DEPARTMENT OF TRANSPORTATION

DEL-71-8.91 (PHASE A)

CONSTRUCT A NEW PARTIAL DIAMOND INTERCHANGE ON I-71 AT SUNBURY PARKWAY. THIS WILL INCLUDE AN ENTRANCE RAMP FROM SUNBURY PARKWAY TO I-71 SB AND AN EXIT RAMP FROM I-71 NB TO SUNBURY PARKWAY. BUILD A I-71 NB CD ROAD BETWEEN SUNBURY PARKWAY AND SR 36/37 COMBINING THE EXITING TRAFFIC TO SUNBURY WITH THE EXITING TRAFFIC TO SR 36/37. CONNECT SUNBURY PARKWAY TO WILSON RD. THE PROJECT WILL ALSO INCLUDE THE SUNBURY PARKWAY TWO SPAN BRIDGE OVER I-71, THE RECONSTRUCTION OF STORM SEWERS AND CULVERTS, AND THE RELOCATION OF SIGNAGE AND LIGHTING. THE FULL PARCLO INTERCHANGE AND THE EXTENSION OF SUNBURY PARKWAY WILL BE BUILT IN FUTURE PHASES.

DESIGN AGENCY  ms consultants, inc.	
DESIGNER ACW	
REVIEWER TAZ 06/29/23	
PROJECT ID 106959	
SHEET P.12	TOTAL 663

REAR ABUTMENT PARTIAL PLAN (1 OF 2)
(MSE WALL NOT SHOWN)

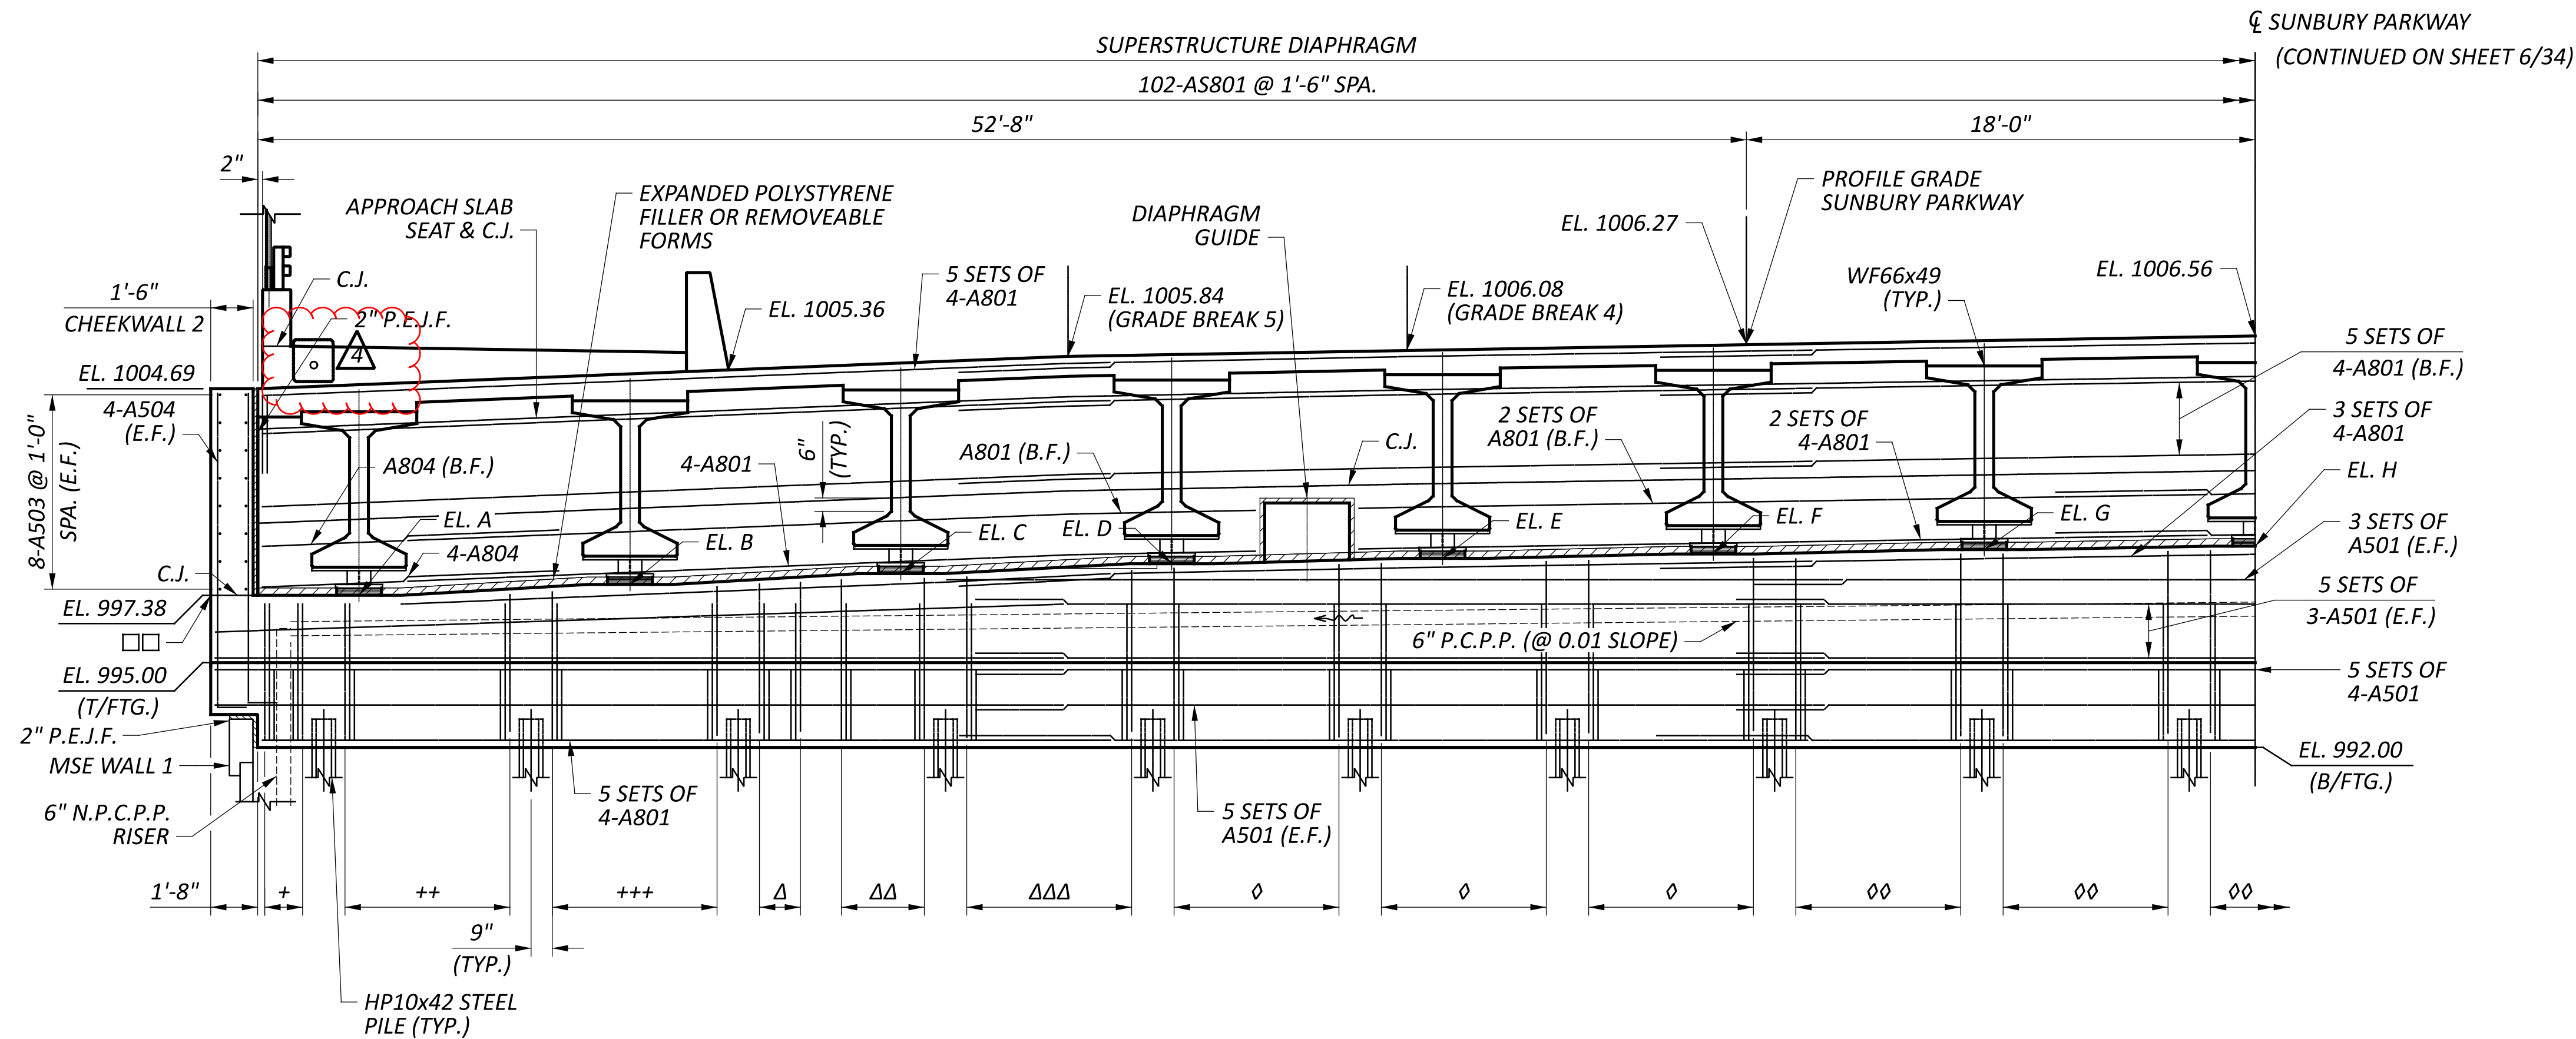
NO.	DESCRIPTION	REV. BY	DATE
PIR4	ADDED LIGHTING CONDUIT	ATM	04/14/25

FORWARD ABUTMENT PLAN AND ELEVATION (1 OF 2)
BRIDGE NO. DEL-00071-08.910
OVER I-71

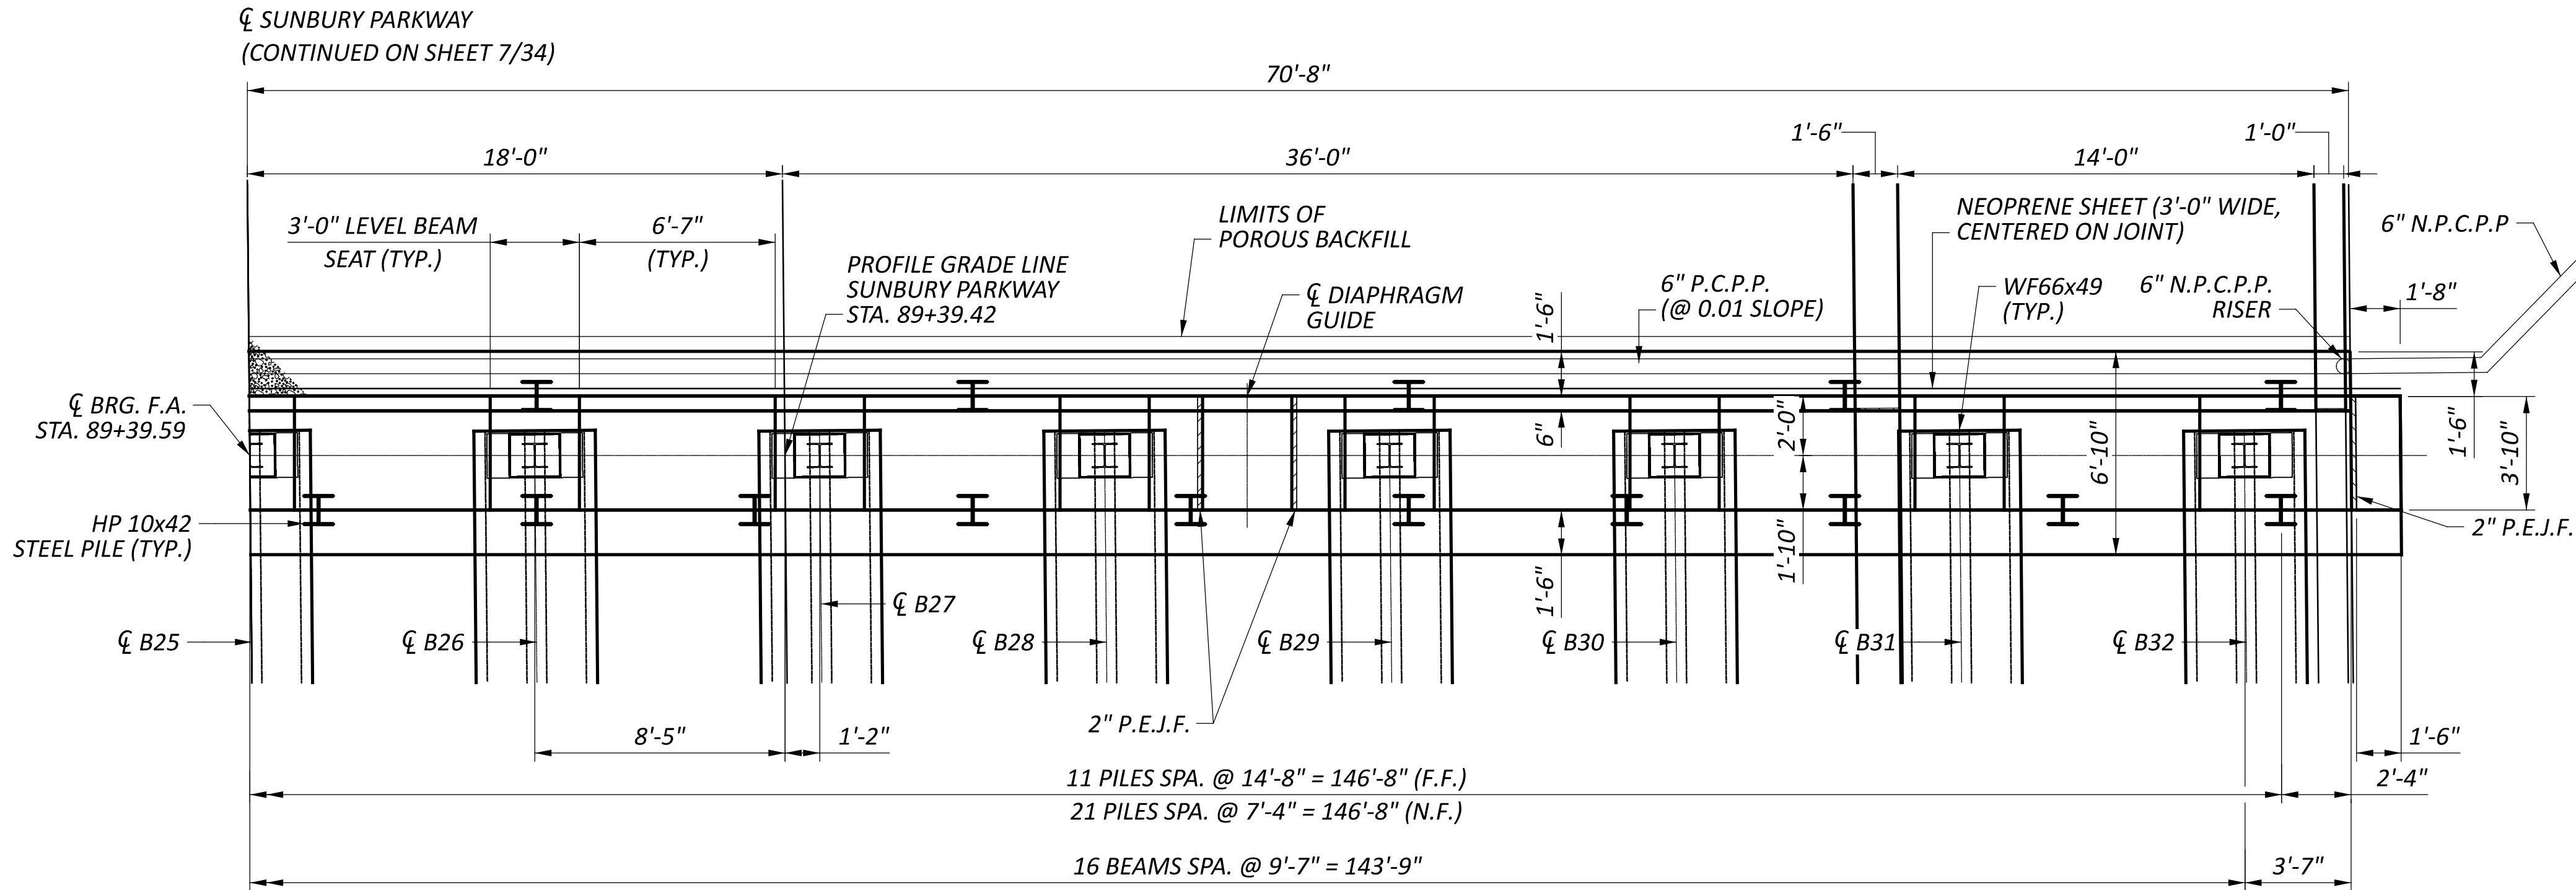
NO.	DESCRIPTION	REV. BY	DATE
PIR4	ADDED LIGHTING CONDUIT	ATM	04/14/25

TYPICAL TRANSVERSE SECTION (1 OF 2)

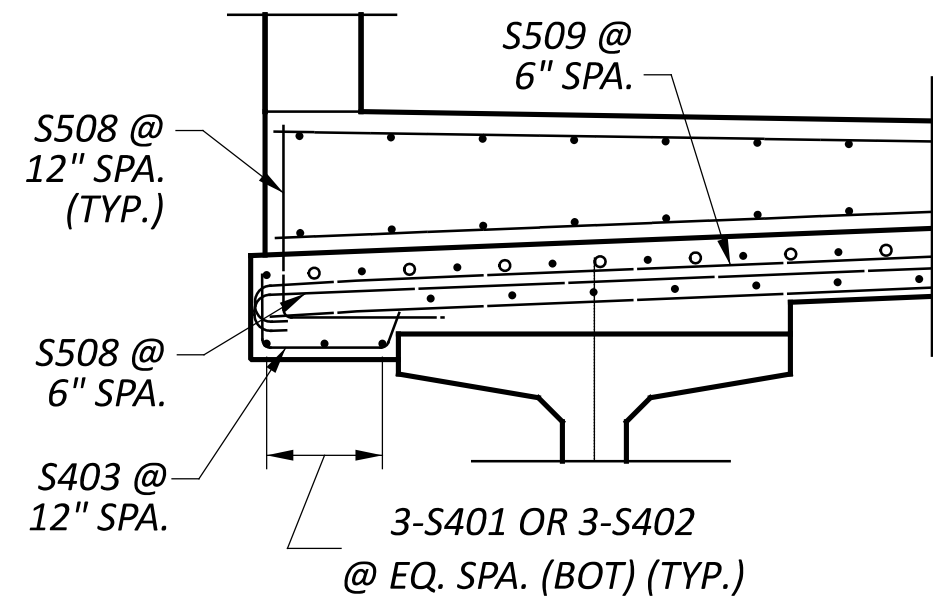
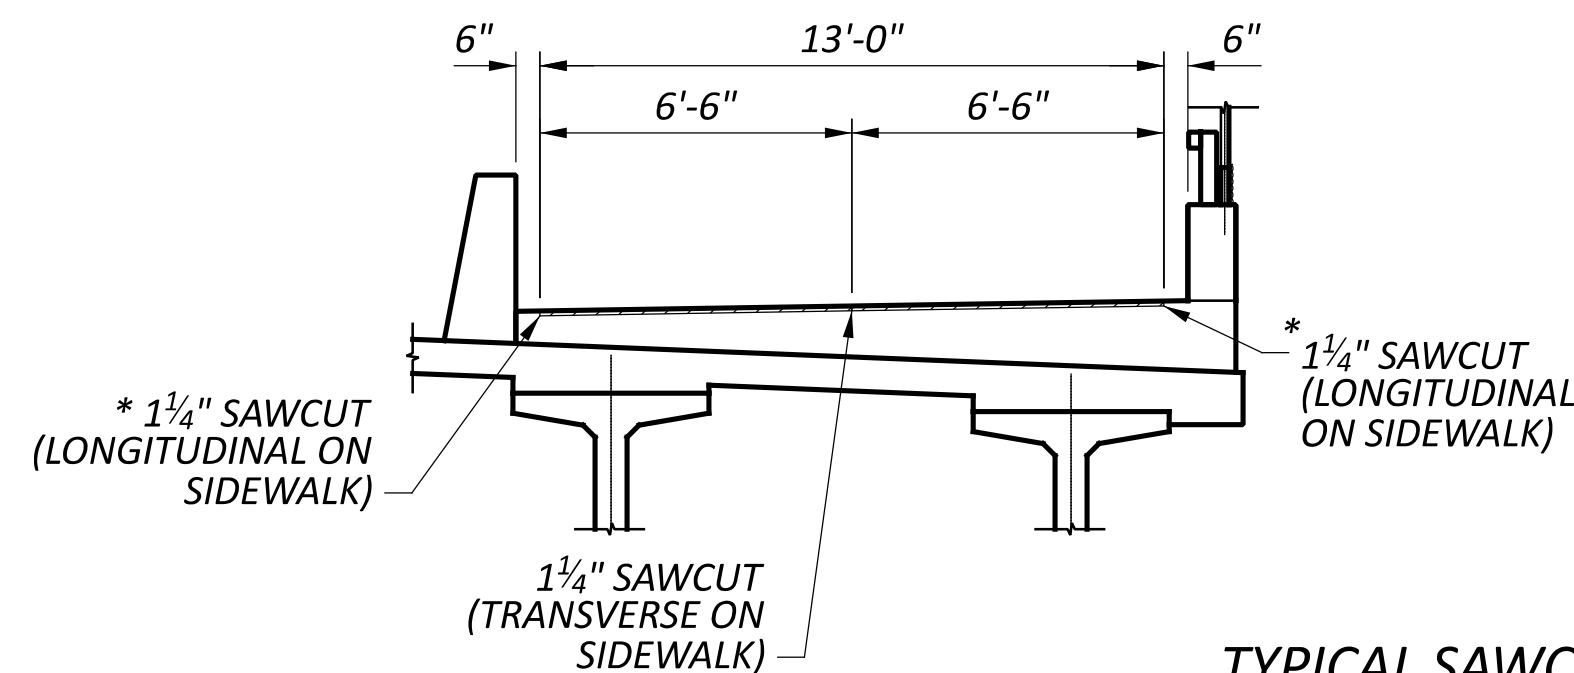
NO.	DESCRIPTION	REV.	BY	DATE
PIR3	ADDED SUP DIMENSIONS	ATM	03/14/25	
PIR4	ADDED LIGHTING CONDUIT	ATM	04/14/25
